LEWISHAM ESTATE – REFERENCE NO.2013SYE022

MODIFICATION REQUEST:

Mixed Use Development at 78-90 Old Canterbury Road, Lewisham Concept Plan

MP 08_0195 MOD 1

Figure 4: Proposed Concept Plan (Source: Proponent's Section 75W application)

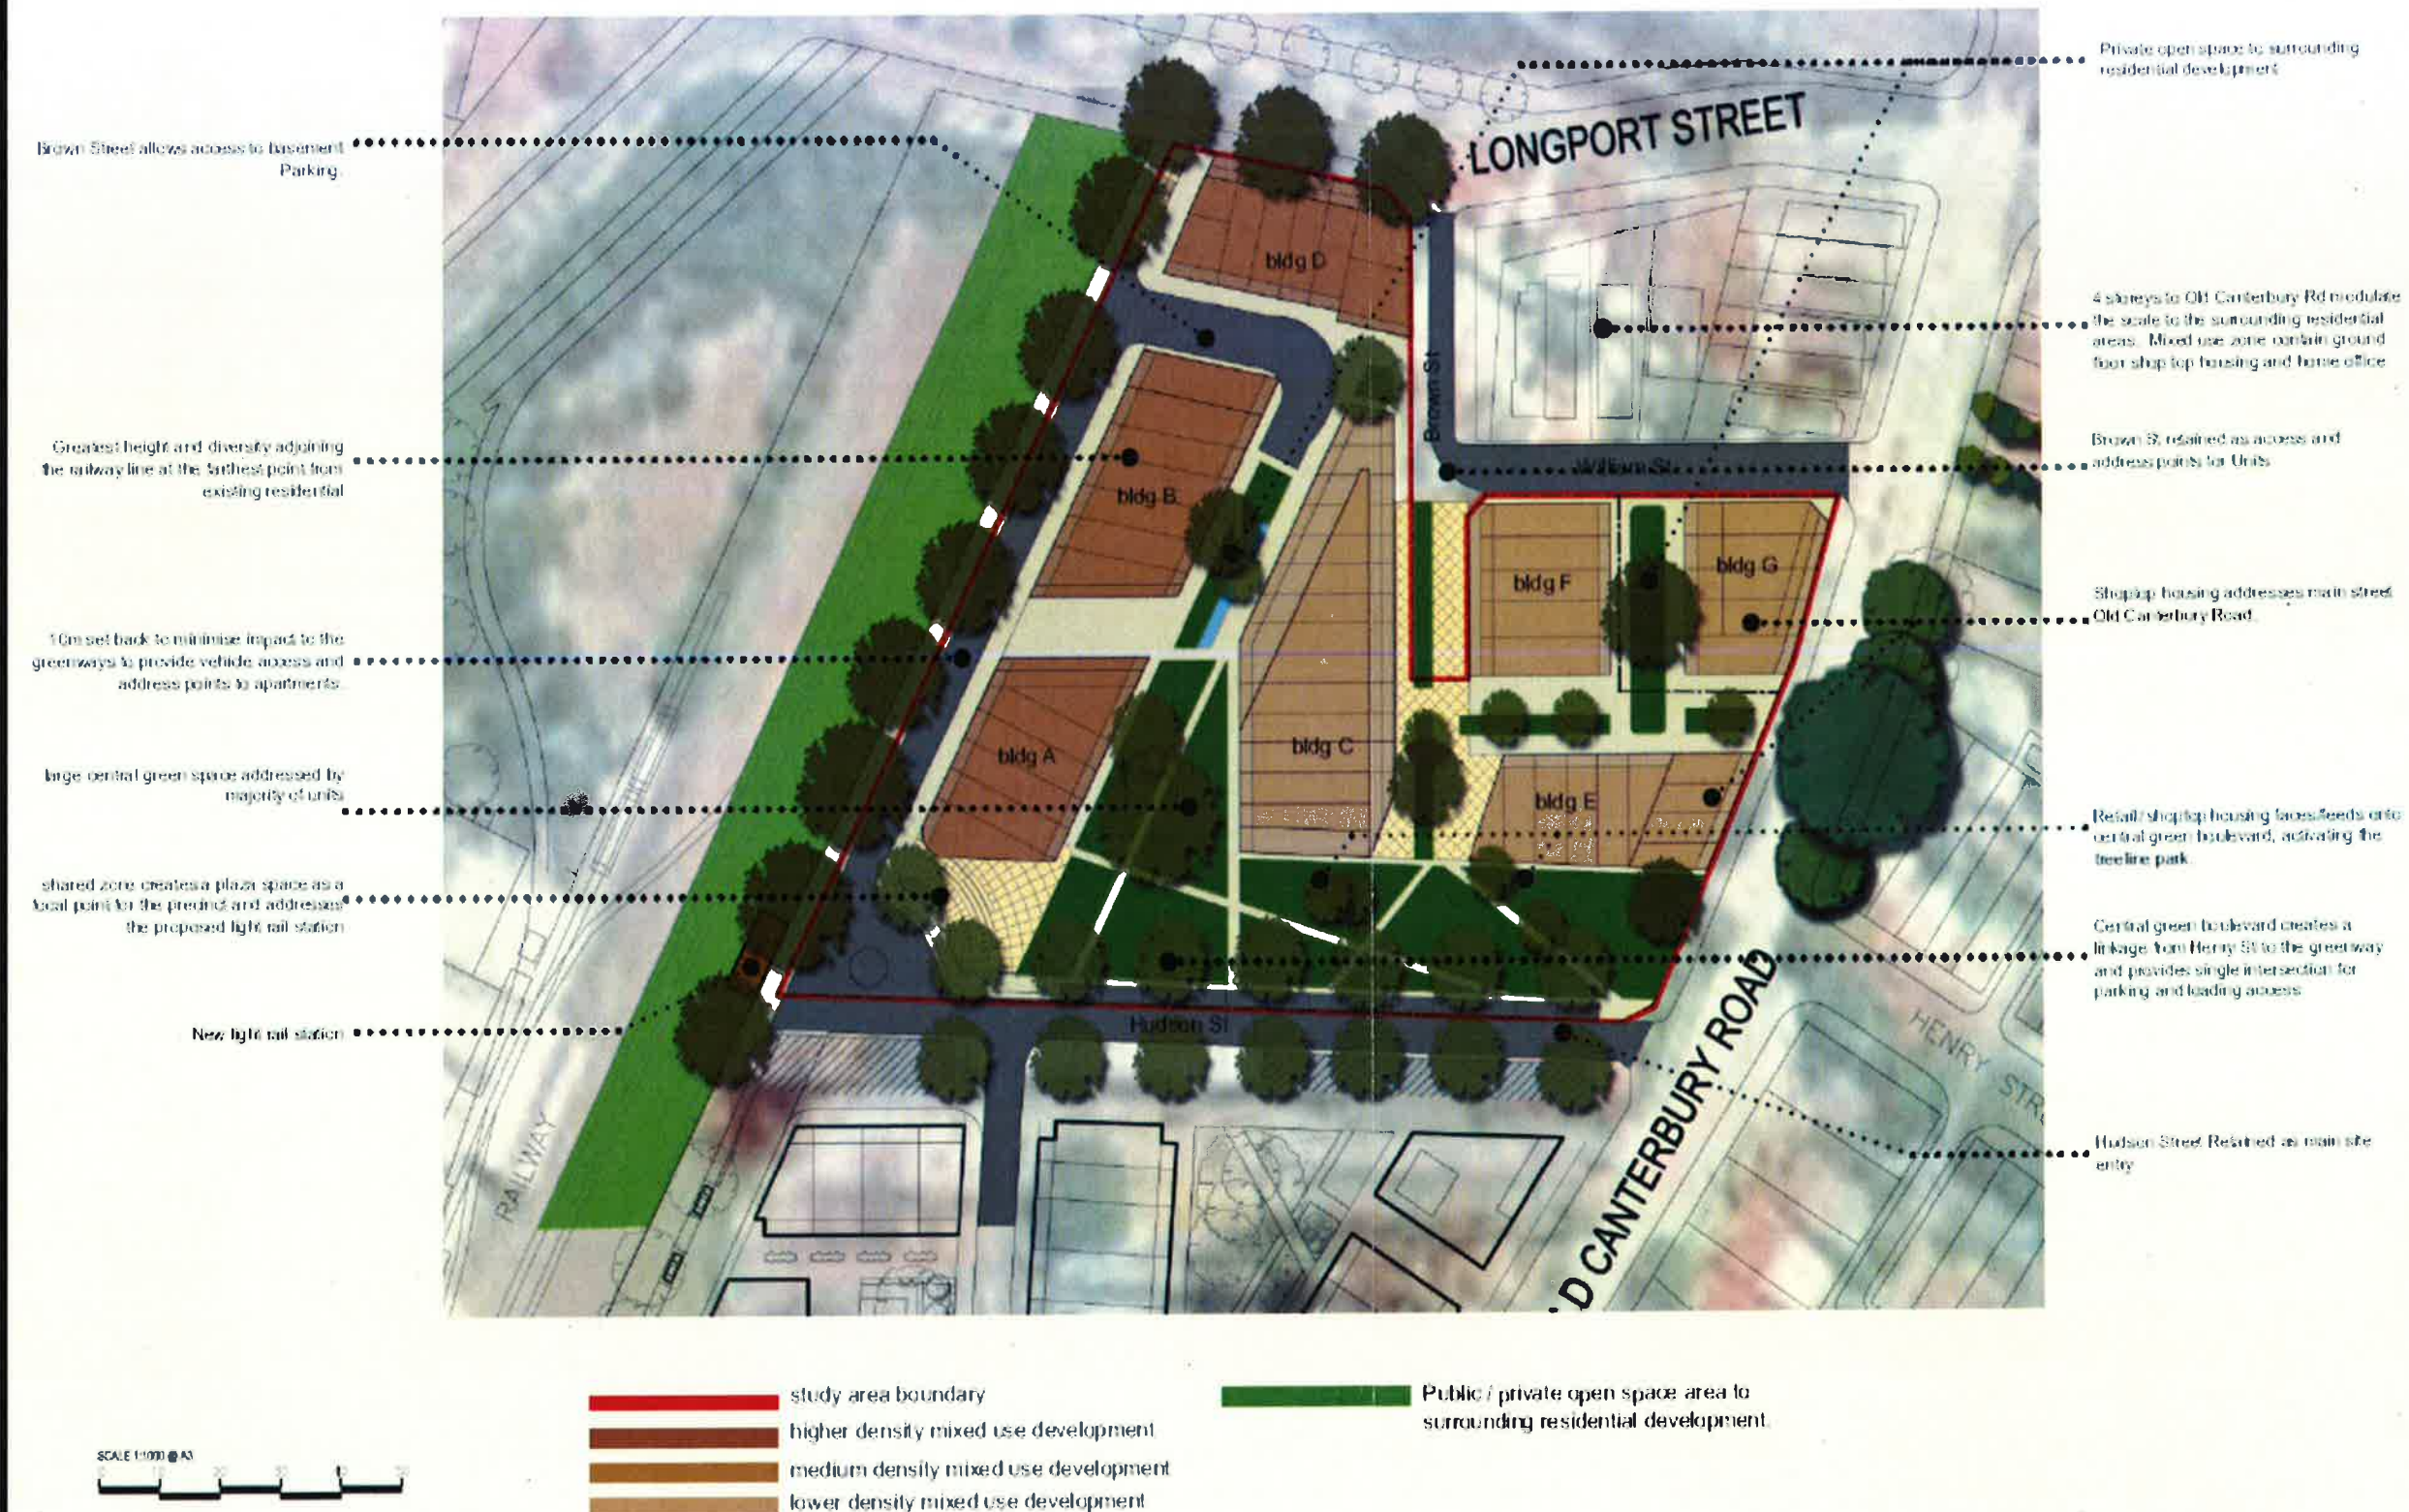
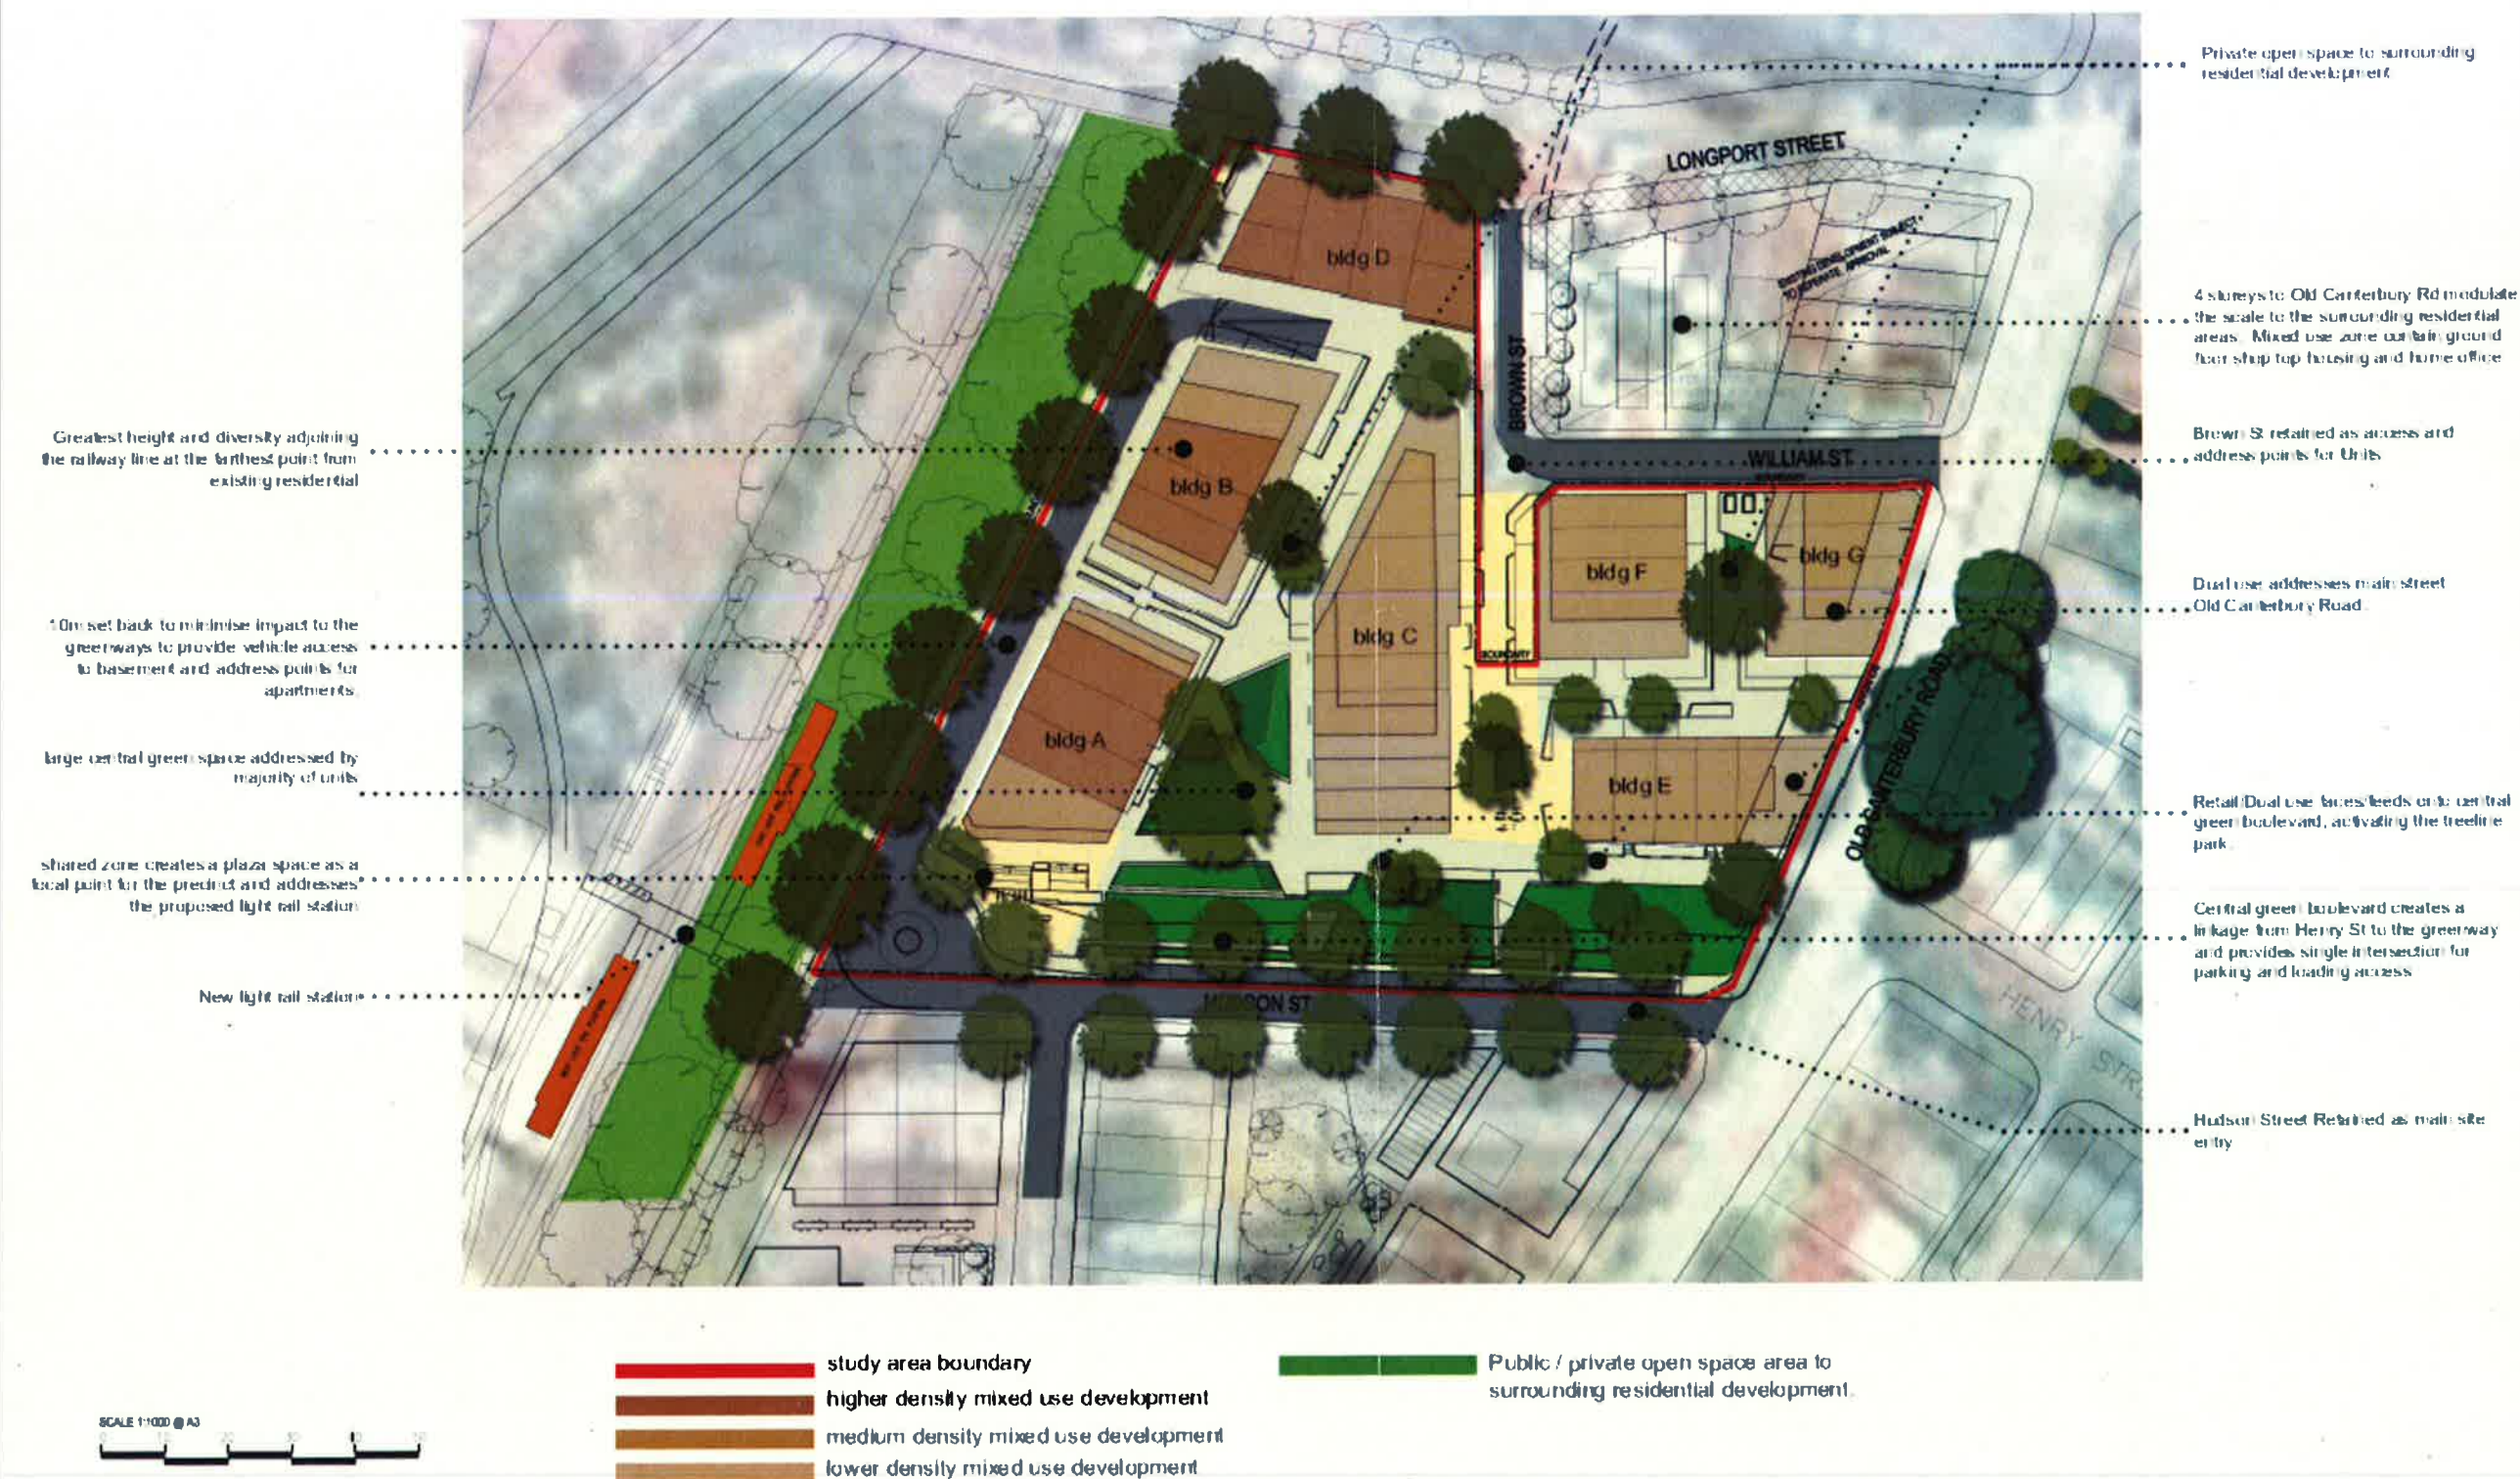
The Proponent seeks approval for a number of changes to the Concept Plan approval consisting of minor adjustments to the alignment of the space between Buildings A and B, the introduction of the concept of "dual use" live-work spaces to provide flexibility in providing ground floor retail / commercial floor space, changes to solar access requirements, clarification around the provision of affordable housing, treatment of the public domain, relocation of the loading dock and the amendment of various conditions of the approval and Statement of Commitments.

- minor adjustments to the alignment of the space between Buildings A and B;
- reduction in the size of the central open space from 3,054.4m² to 3,002.1m²;

- modulation of approved building heights;
- changes to the land use plan:
 - redefinition of the ground floor uses in Buildings A, C and G to be retail and commercial. It is proposed to make provision for these spaces to be "dual use", enabling them to be used for either residential or non-residential; and

- deletion of the requirement for non-residential land use along the north-south access road.
- vary the minimum solar access requirements from a minimum of 3 hours between 9.00am and 3.00pm in mid-winter to a range of between 2 and 3 hours;

The proposed Concept Plan layout is shown in **Figure 4**.
